Application Details	
Application Reference Number:	42/22/0043
Application Type:	Section 73 – Variation of Condition
Description	Variation of Condition No. 02 (approved plans), for the inclusion of a turning head at the entrance of the approved pumping station compound, of application 42/20/0042 at Orchard Grove New Community, Comeytrove Rise, Taunton
Site Address:	Orchard Grove, Land off Comeytrove Lane, Taunton
Parish:	Trull
Conservation Area:	No
Somerset Levels and Moors RAMSAR Catchment area:	Yes
AONB:	No
Case Officer:	Simon Fox, Major Projects Officer (Planning) 07392 316159 s.fox@somersetwestandtaunton.gov.uk Should you wish to discuss the contents of this report item please use the contact details above by 5pm on the day before the meeting, or if no direct contact can be made please email: planning@somersetwestandtaunton.gov.uk
Agent:	Boyer Planning
Applicant:	TAYLOR WIMPEY UK LTD, VISTRY WESTERN, SUMMERFIELD DEVELOPMENTS

APPLICATION FOR VARIATION OF CONDITION NO. 02 (APPROVED PLANS), FOR THE INCLUSION OF A TURNING HEAD AT THE ENTRANCE OF THE APPROVED PUMPING STATION COMPOUND, OF APPLICATION 42/20/0042 AT ORCHARD GROVE NEW COMMUNITY, COMEYTROWE RISE, TAUNTON

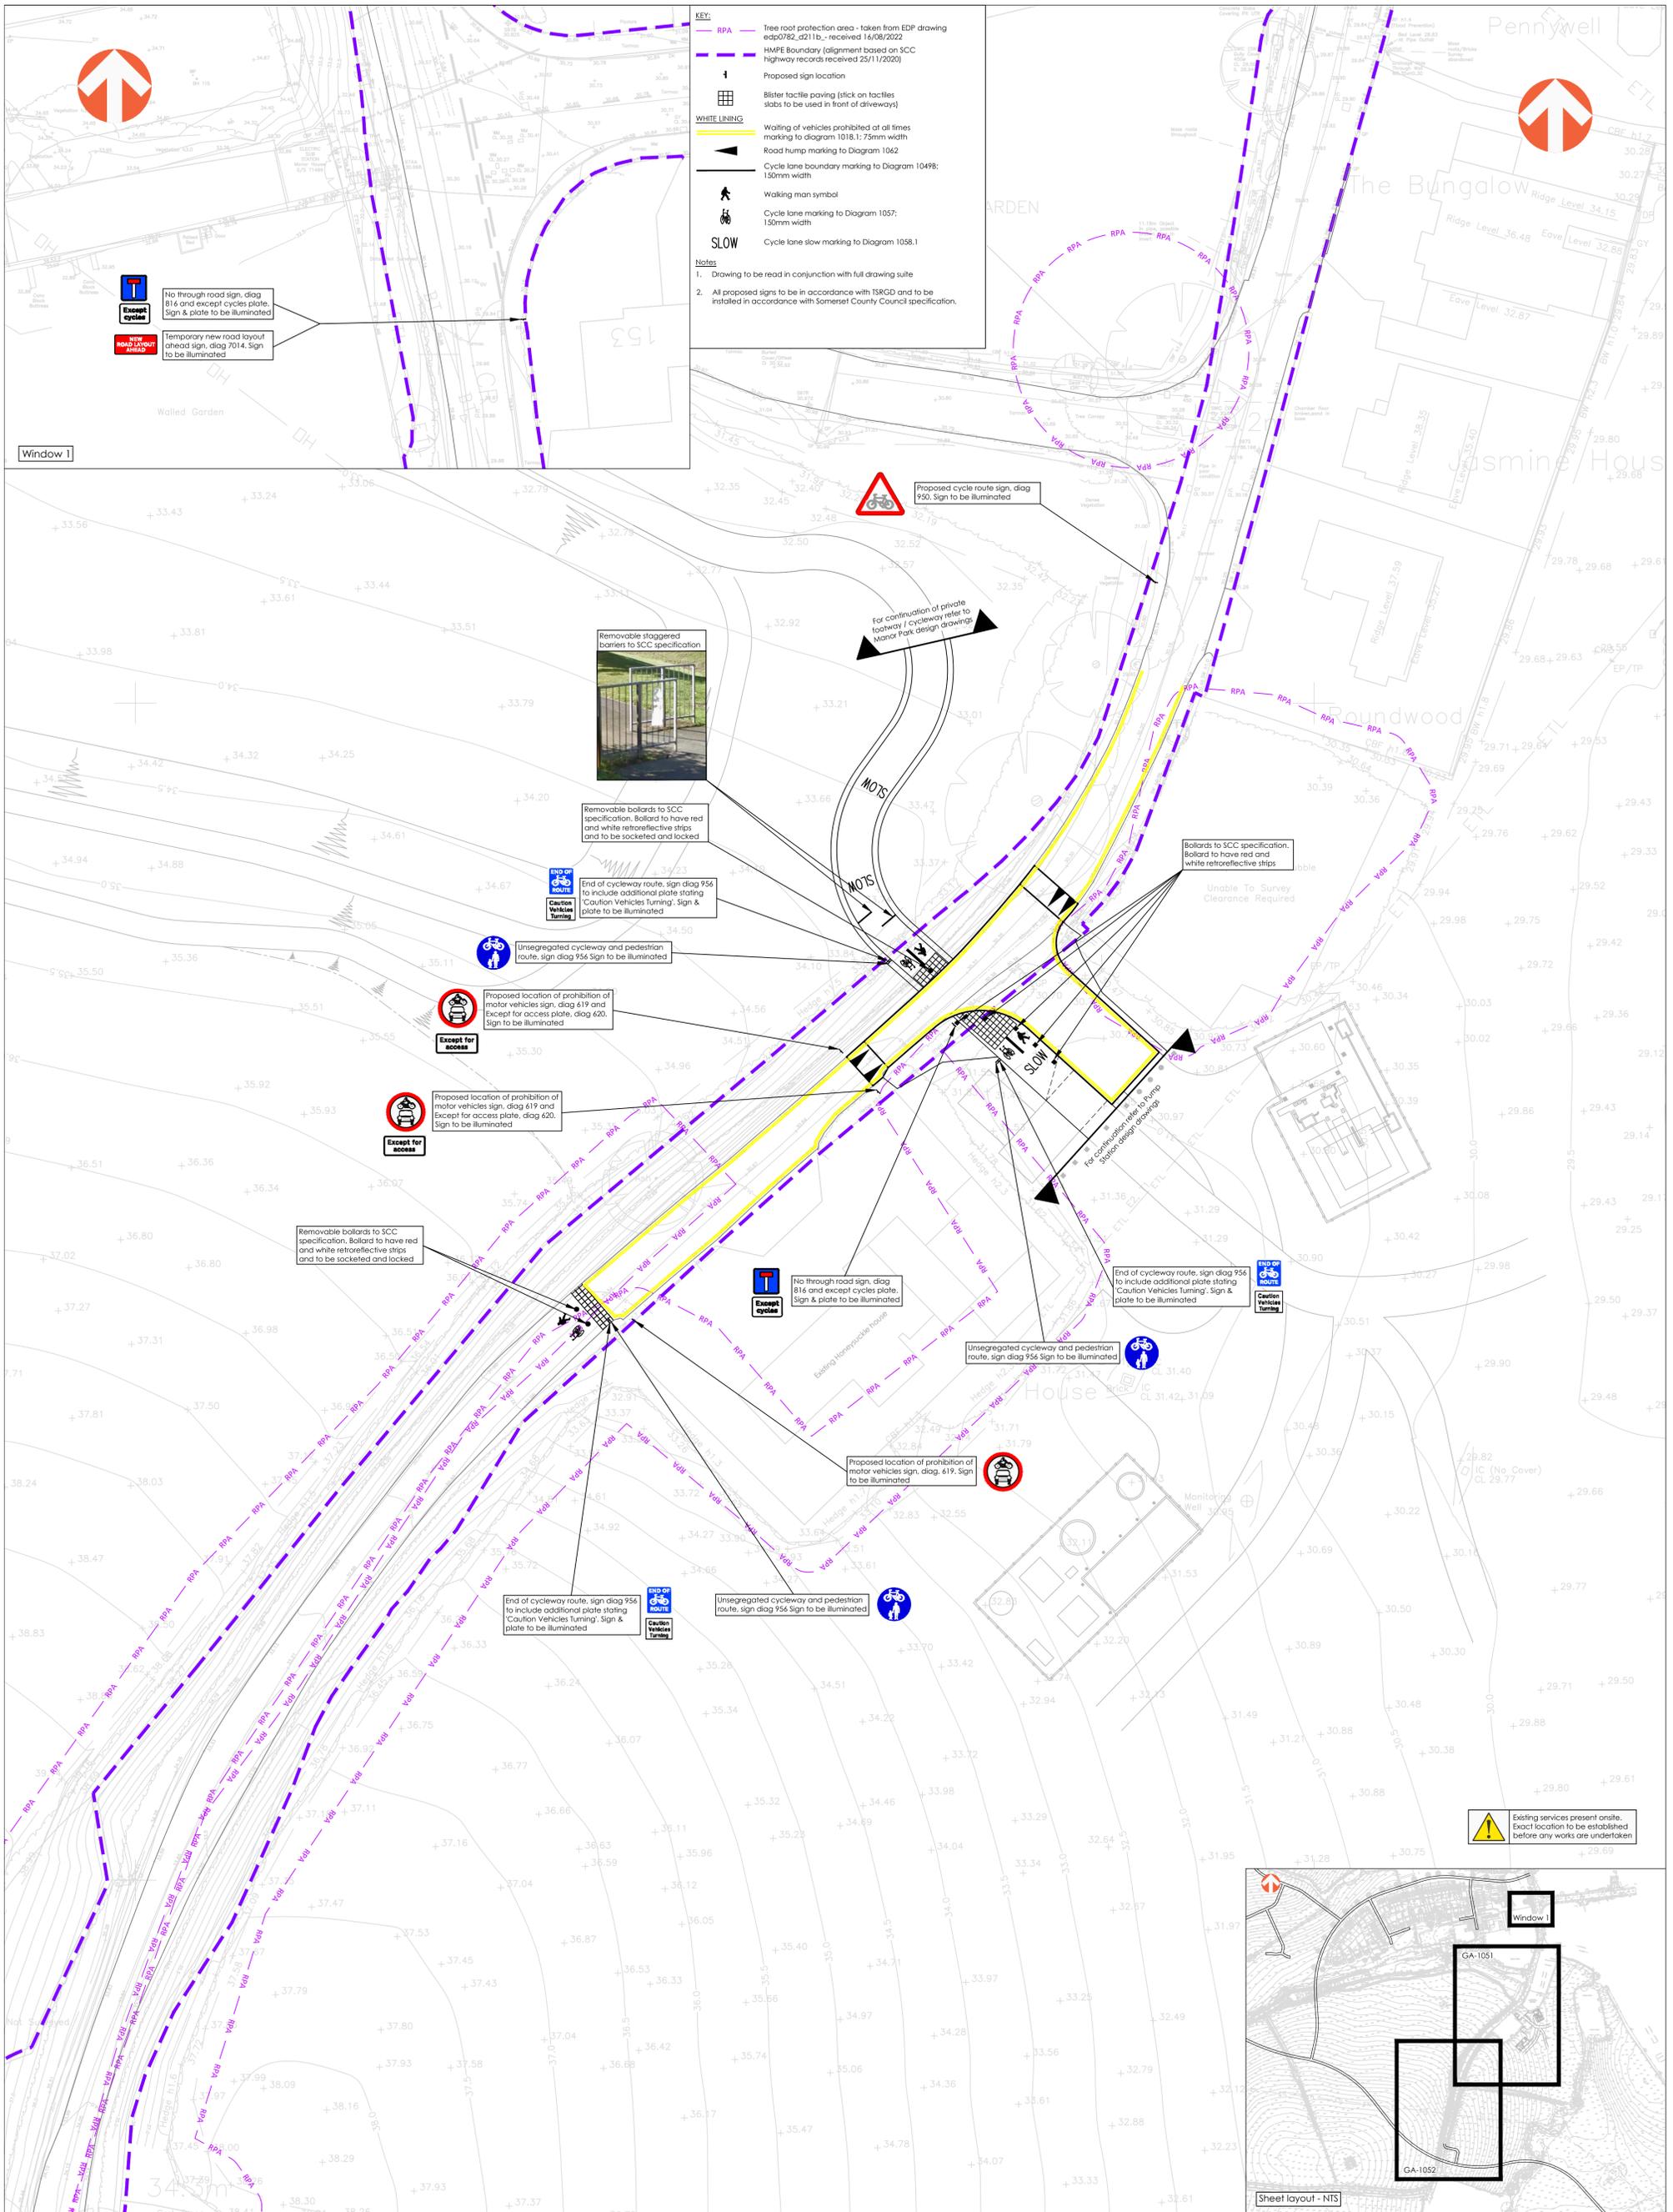
1.6 We have set out a detailed comparison between the plans approved by the Planning Committee (which include the proposed amendment to increase the size of the access bellmouth) with the suggested alternative location.

<p>before having priority progressing through the park</p>	<p>proposed route, crossing in the vicinity of the proposed turning head and then proceeding along the pumpstation access, before continuing back on the footway/cycleway within Horts Bridge Park. Clearly short cuts down a steep embankment could present a safety hazard.</p>
Vertical Alignment	<p>The vertical alignment of the private shared footway/cycleway is proposed no steeper than 1:14 (based on minimum SCC guidance) with a 2.4m level area (1:40) at the point of crossing Comeytrove Lane.</p>	<p>The vertical alignment of the private shared footway/cycleway is shown no steeper than 1:14 (based on minimum SCC guidance) with a 2.4m level area (1:40) prior to intersecting Comeytrove Lane. To achieve an acceptable gradient the alternative option results in a significantly long route</p>
Earthworks	<p>Earthworks/banking is required at a maximum grade of 1:3 (self-supporting) to enable the proposed footway/cycleway to grade down to Comeytrove Lane. This is over an approximate length of 35m. The height of the existing sunken lane on the northern side of Comeytrove Lane is approximately 3.4m, with the lane being at level on the southern side, so not requiring any earthworks. This results in approximately 767m³ of excavated material.</p>	<p>Earthworks/banking is required at a maximum grade of 1:3 (self-supporting) to enable the proposed private shared footway/cycleway to grade down to Comeytrove Lane. This is over an approximate length of 80m. The height of the existing sunken lane at this location, on the northern side, is approximately 4.2m, and 1.4m on the southern side adjacent to honeysuckle house This results in approximately 2,001m³ of excavated material with the extents identified on the alternative sketch option.</p>

Street lighting	<p>There is no existing street lighting on Comeytrove Lane in this location. The nearest and last existing streetlight is 143m northeast at the junction with Queens Way. However, due to the proposed turning head, Pumpstation service access and footway/cycleway link all</p>	<p>Once again there is no existing street lighting on Comeytrove Lane in this location. The nearest and last existing streetlight is positioned 191m northeast at the junction with Queens Way. However, as this becomes a rural lane and the alternative option</p>

D	21.11.2022	ADDITIONAL BOLLARDS AND CYCLE WARNING PLATE SIGN ADDED STATING 'CAUTION VEHICLES TURNING' IN RESPONSE TO FURTHER PLANNING COMMENTS	JBE	RJM	PDM																		
C	18.08.2022	CYCLE PRIORITY CROSSING REMOVED AND UPDATED TO SUIT	OJT	RJM	PDM

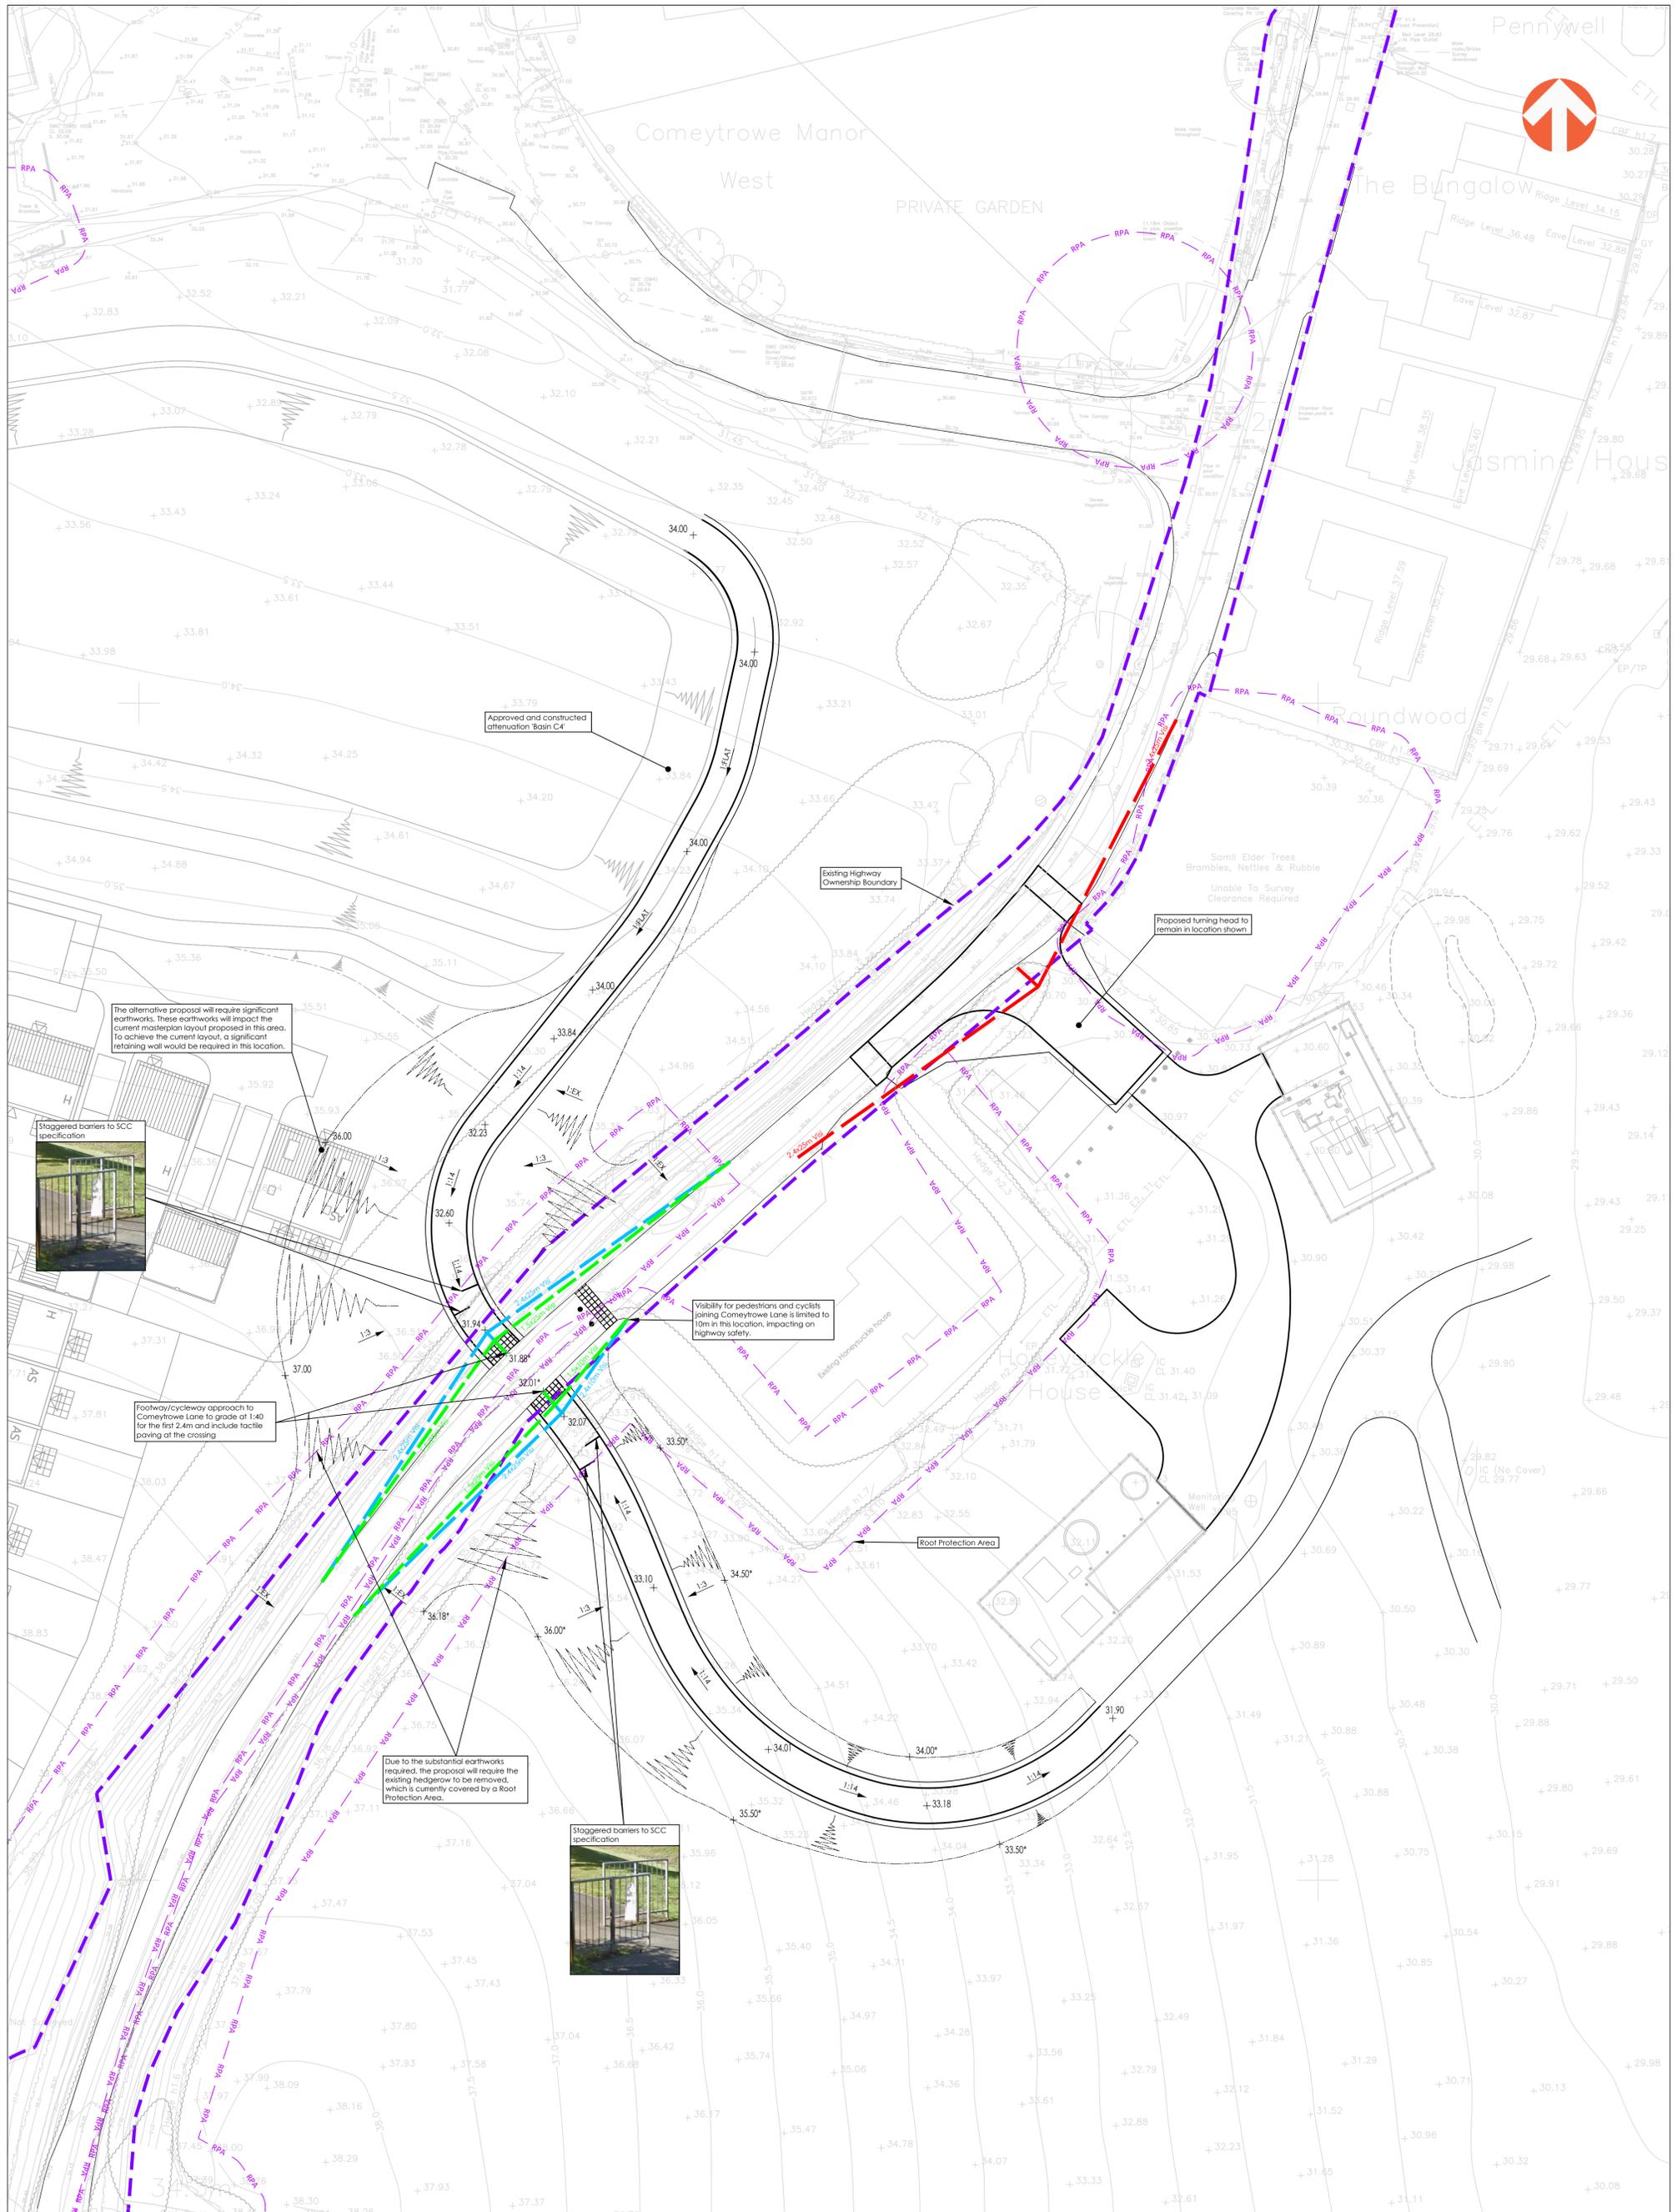
Signing and lining	The proposed signing is in line with current national guidance (TSRGD and TSM) and is shown on the proposed supporting signing drawing 1083-03-J-GA-1051-Rev D. The proposed signs identify no through traffic accept access, prohibition of motorised vehicles, appropriate footway/cycleway signing for an uncontrolled crossing; as well as the addition of caution of vehicles turning and cycle warning signs.	Although the pedestrian/cycleway would be removed from the proposed turning head location, it is envisaged that many of the same signs would be required for the alternative option, similar to those currently proposed on the supporting signing drawing 1083-03-J-GA-1051-Rev D. However, as these areas are not required or proposed to be lit, illuminated signs would not be required.
Other Highway features	The turning head is proposed as a tabletop with ramps to reduce vehicle speed. Tactile paving is proposed at the footway/cycleway crossing of Comeytrove Lane again informing pedestrians & cyclist that vehicles on carriageway have priority. A series of bollards are proposed adjacent to the southern footway/cycleway	The proposed turning head is to remain in position as a tabletop with ramps to reduce vehicle speed. Although the alternative footway/cycleway is south of Honeysuckle House, tactile paving would still be required at the crossing of Comeytrove Lane. This is to inform pedestrians & cyclist to give way to those travelling
